Revision	Description	Date
A	Initial Release	?
B	As built changes: E990211-00-C	5/99
C	1. Added compensation networks to coil drivers with capacitors, Cadd1 through Cadd10 and resistors Radd1 through Radd5 2. Changed coil driver 183 ohm (R202, R216, R229, R243, R256) to 125 ohm, 2 Watt for ITMX and ITMY and to 183 ohm 1 watt on all other chassis. 3. Cadd11 through Cadd14 added to board to stabilize and limit high freq gain of 1Hz zero, 40Hz pole compensation stage. 4. Dadd1 through Dadd20 added to coil driver for op amp input protection.	2/00

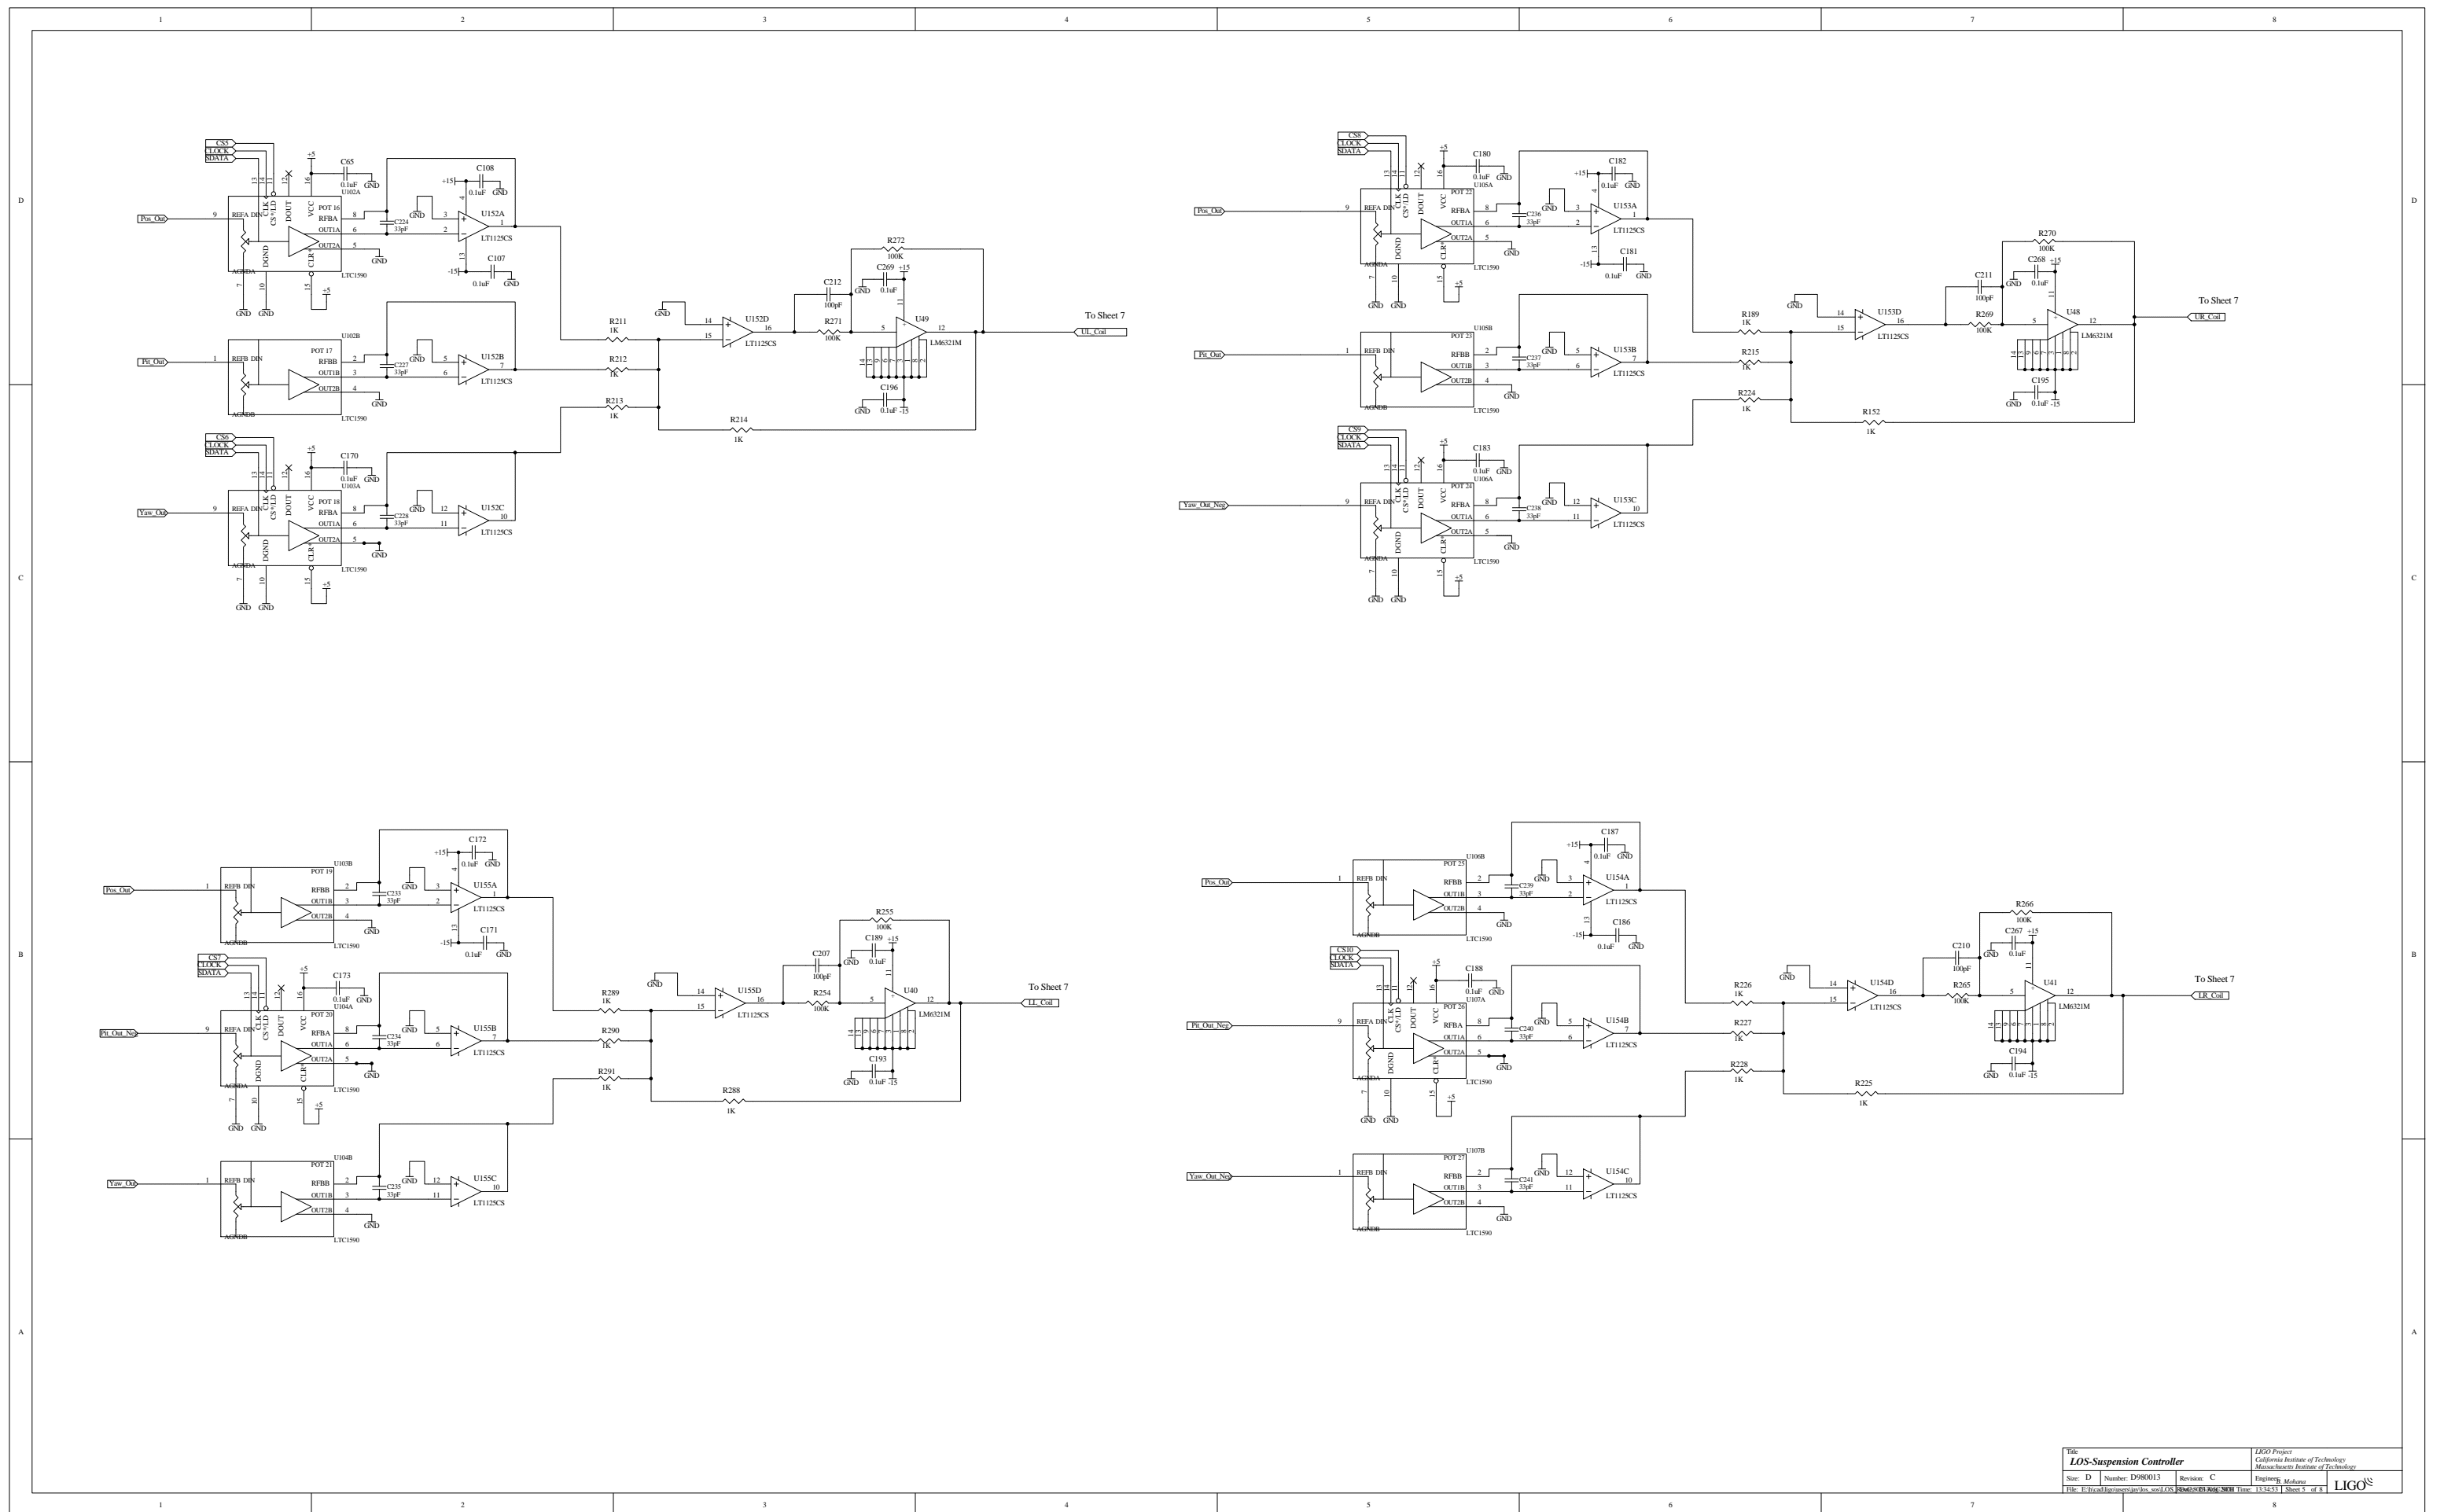
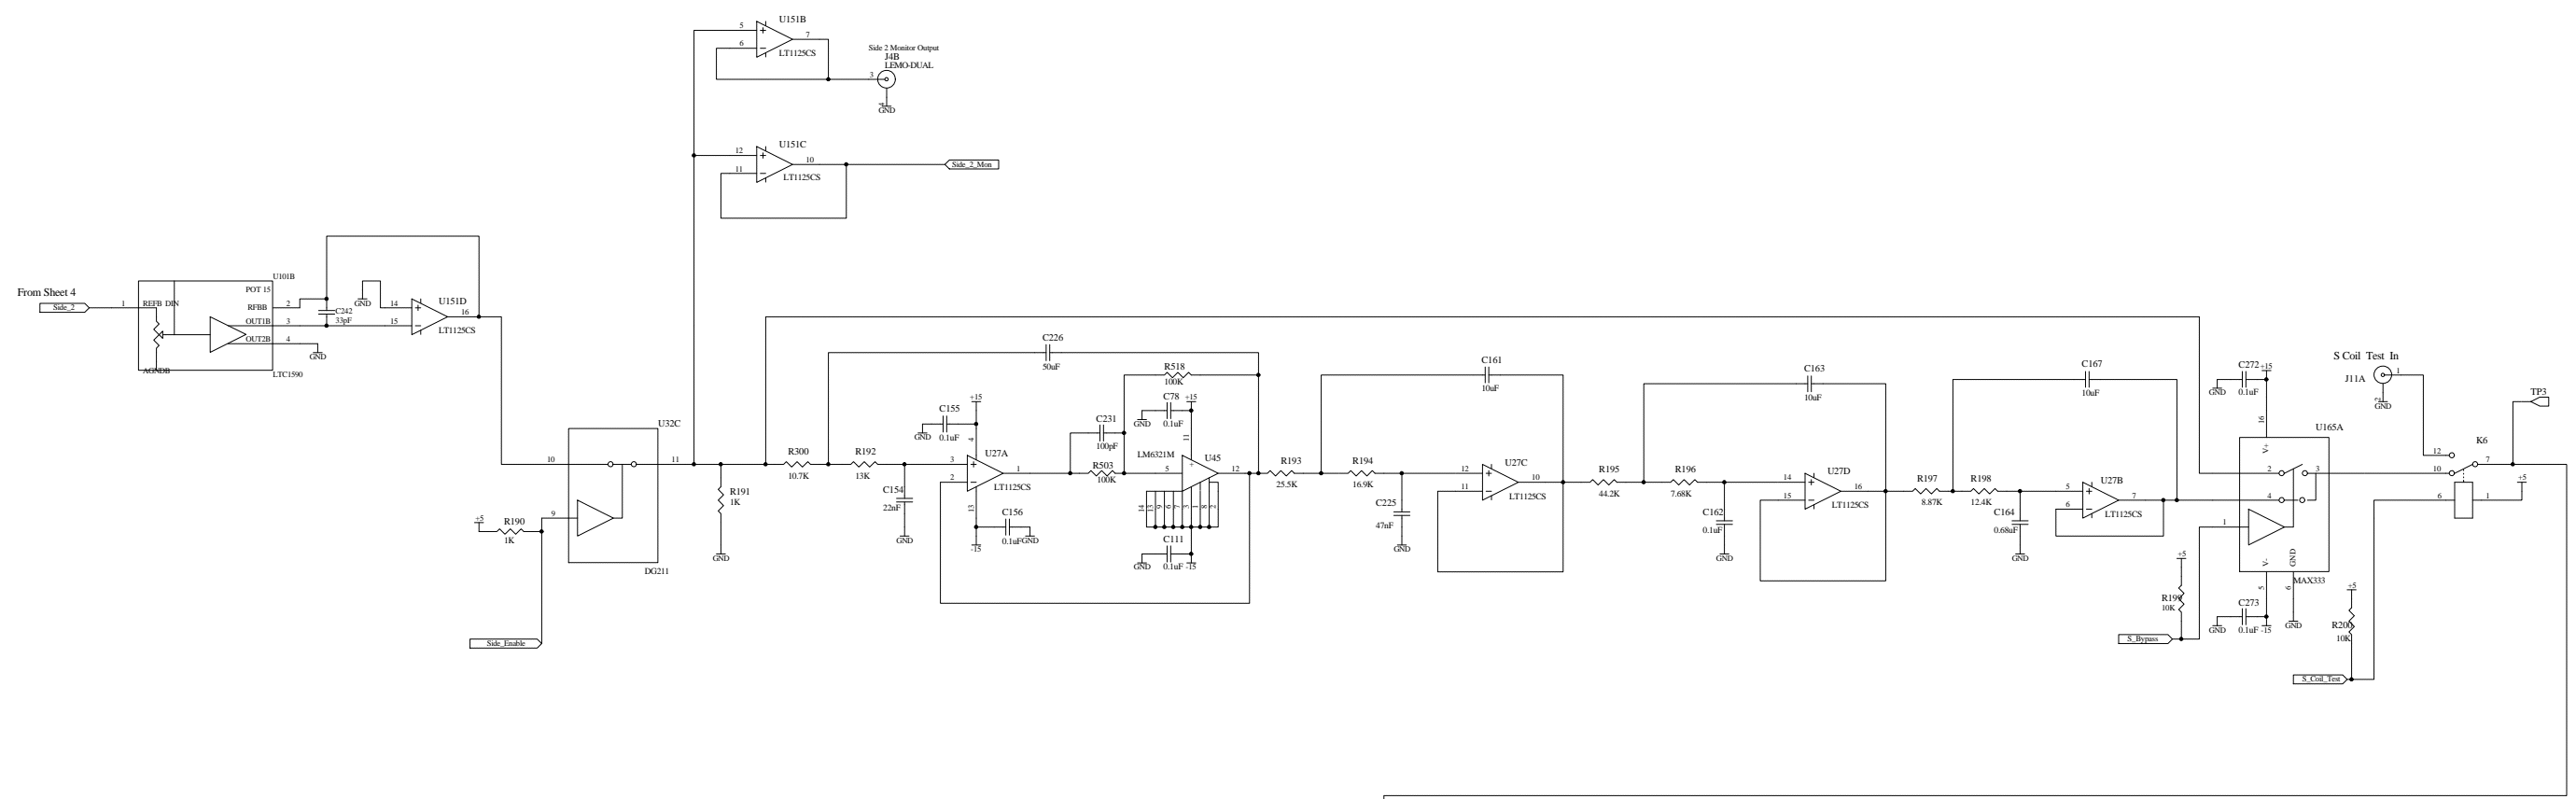
Note:  
402-ohm resistor and 10nF capacitor are not stuffed on LOS controllers for the RCM and BS.

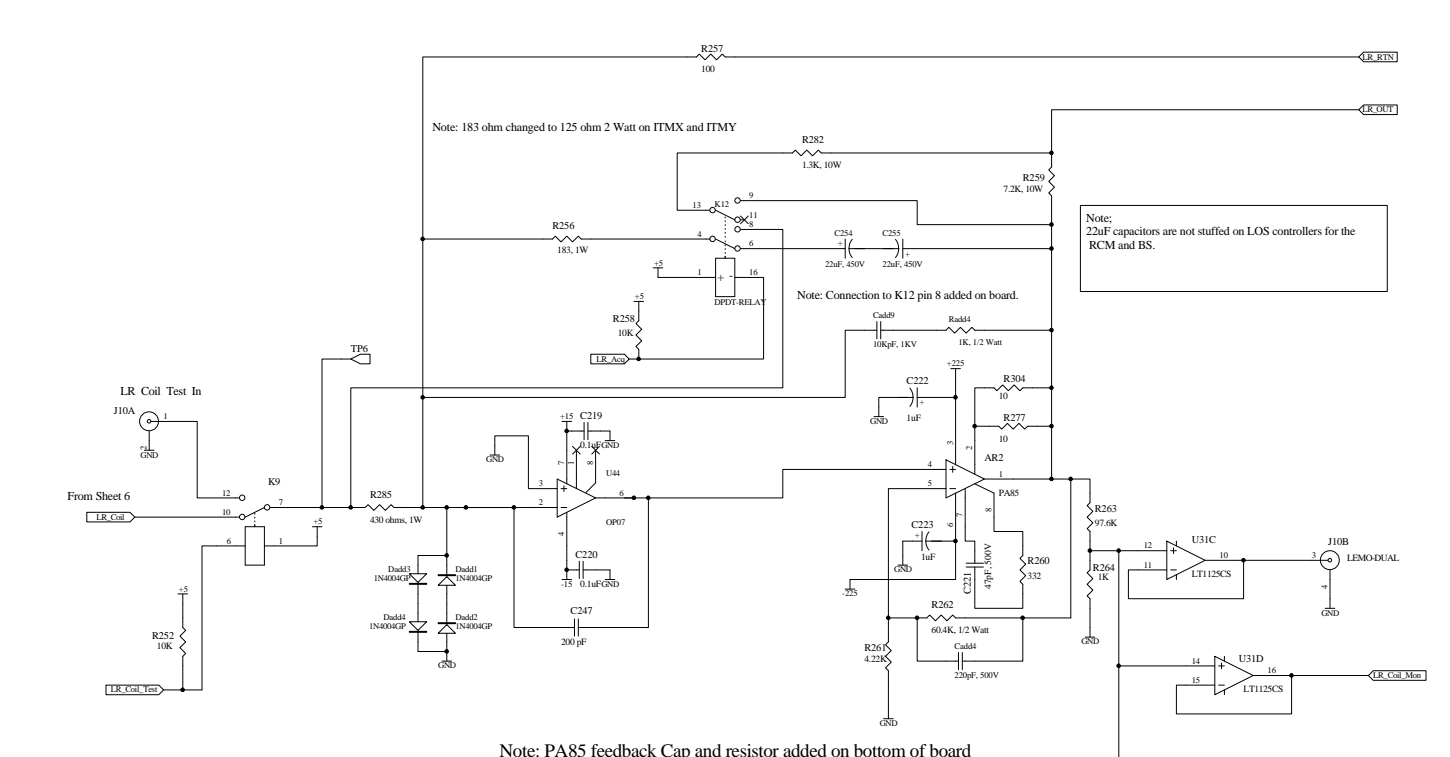
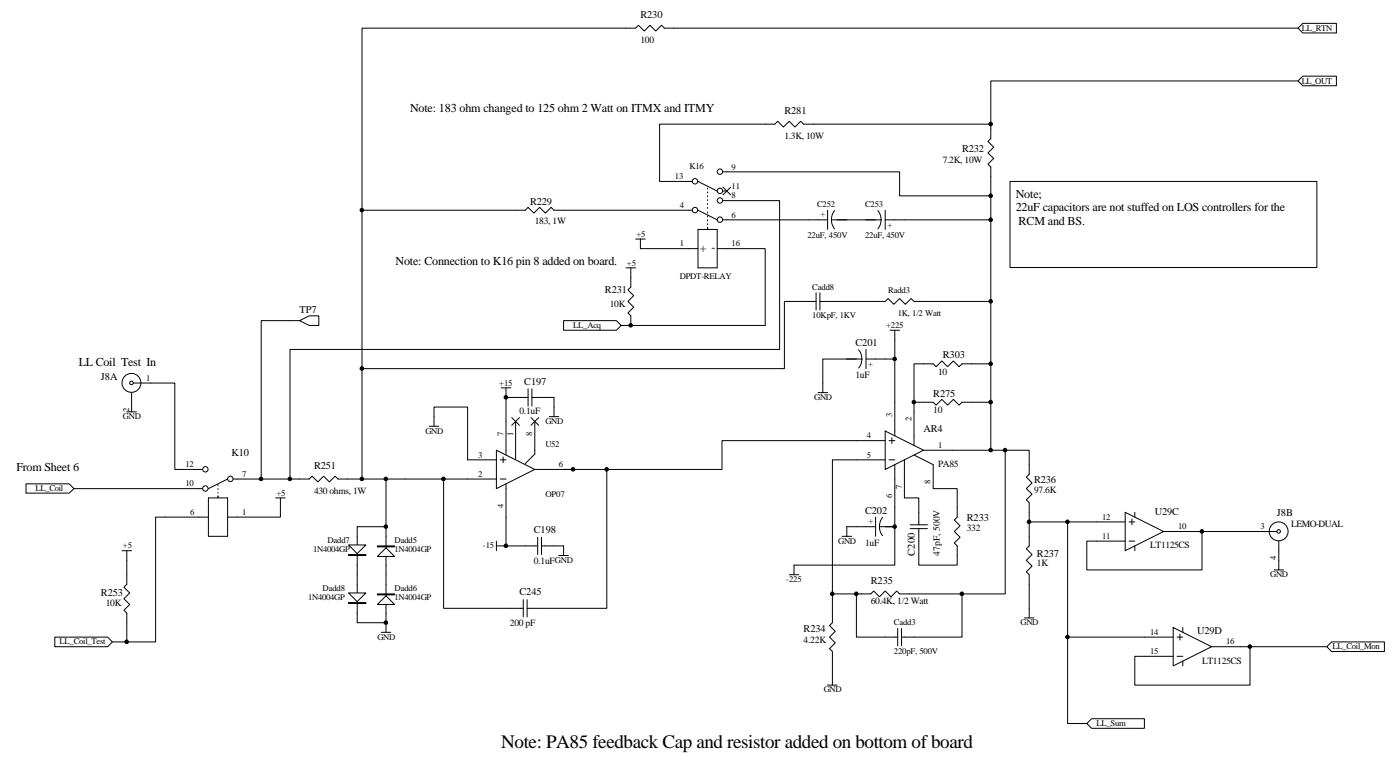
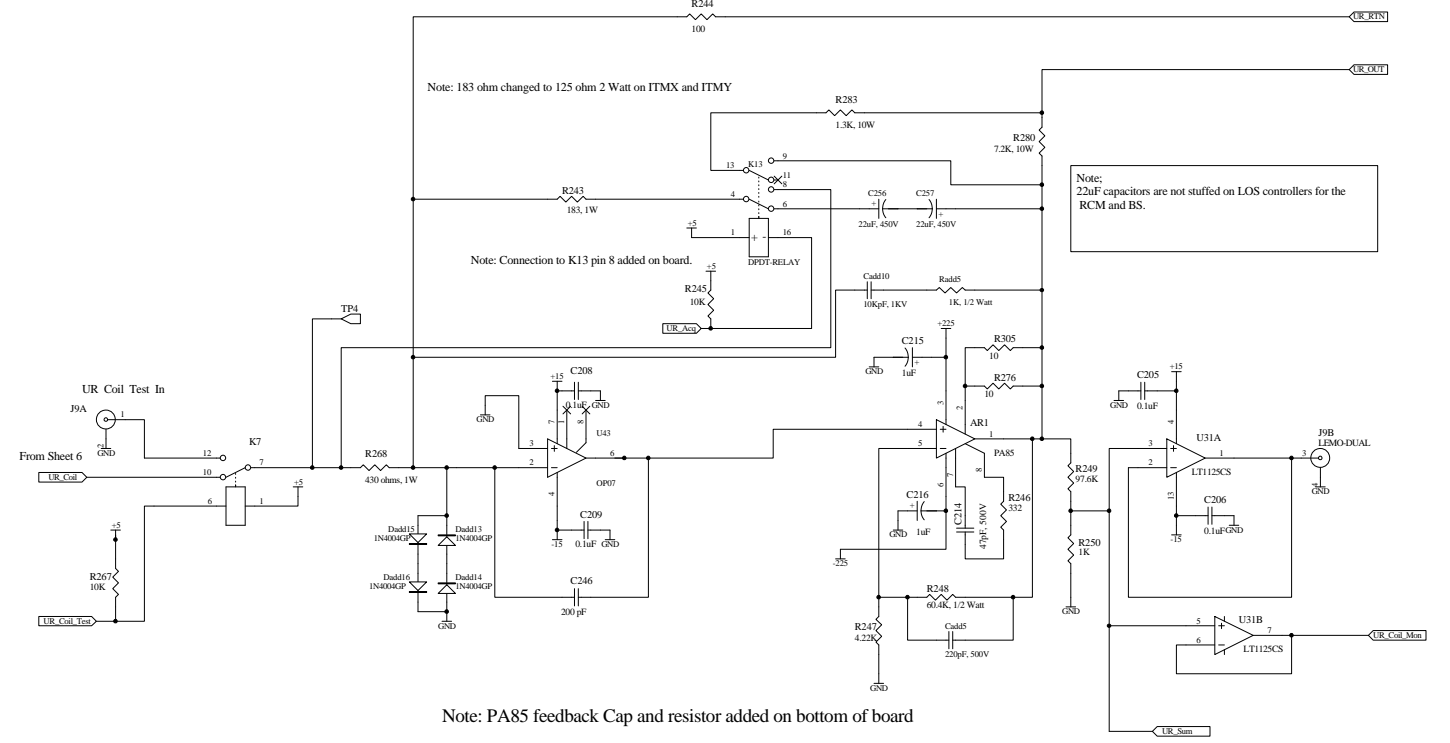
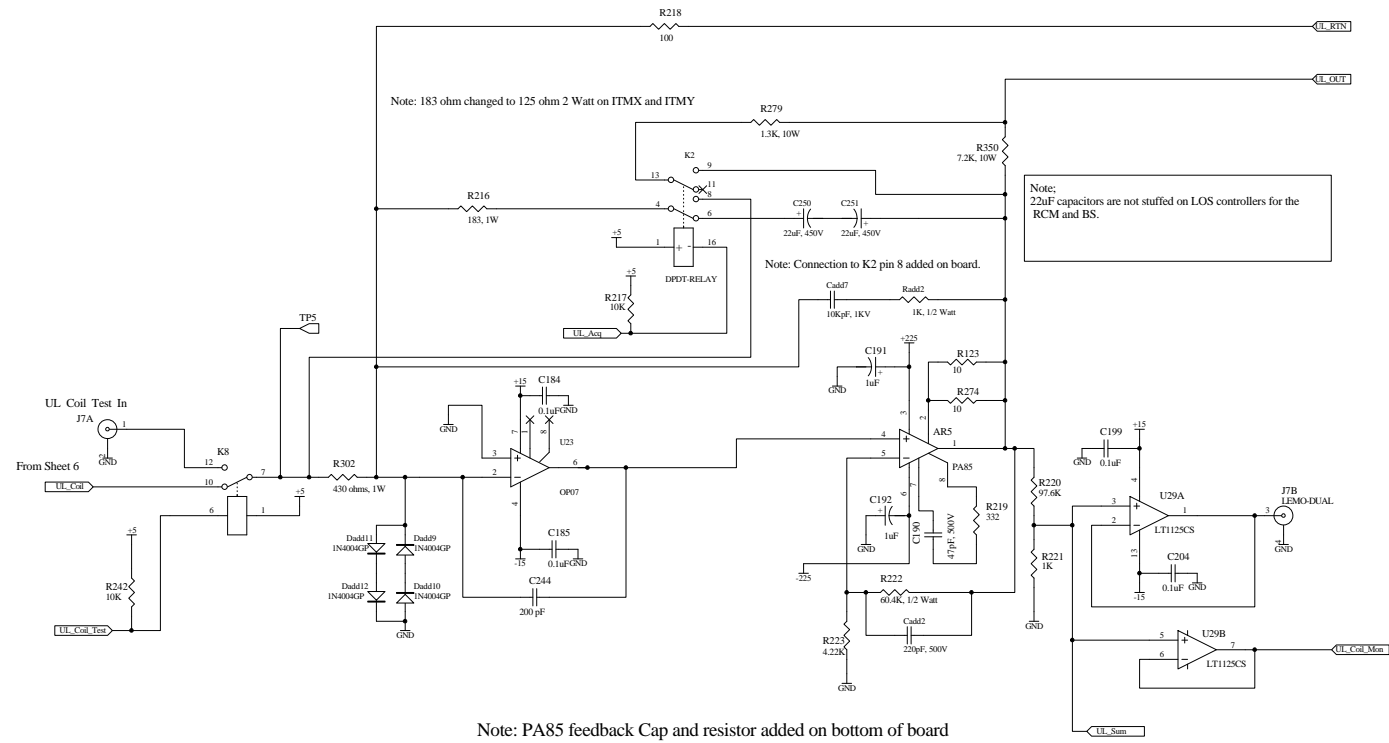
Note: PA85 feedback Cap and resistor added on bottom of board

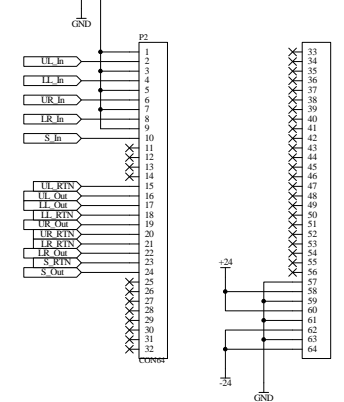
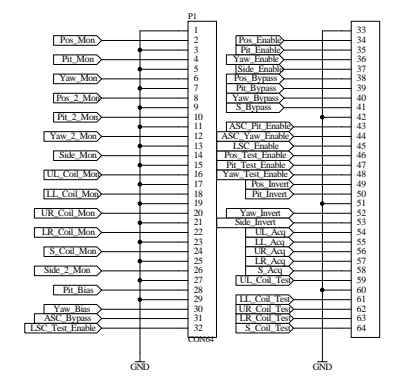
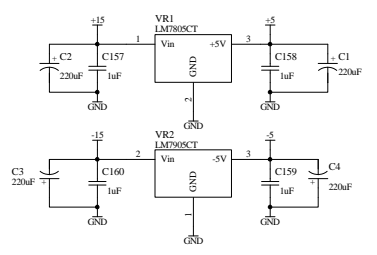
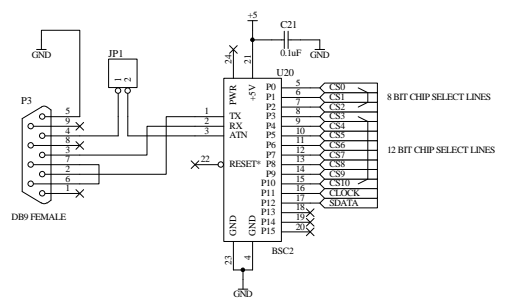
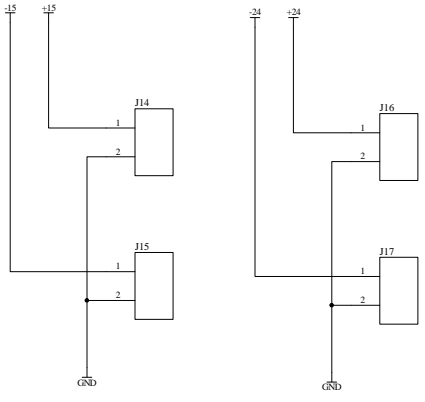
Note:  
The wiring to the daughter card was changed after board manufacture. The actual connections to the board are made via wires to the coil driver outputs. The PD connections remain as shown.  
An interface board (ref. D990022) is used for this function.
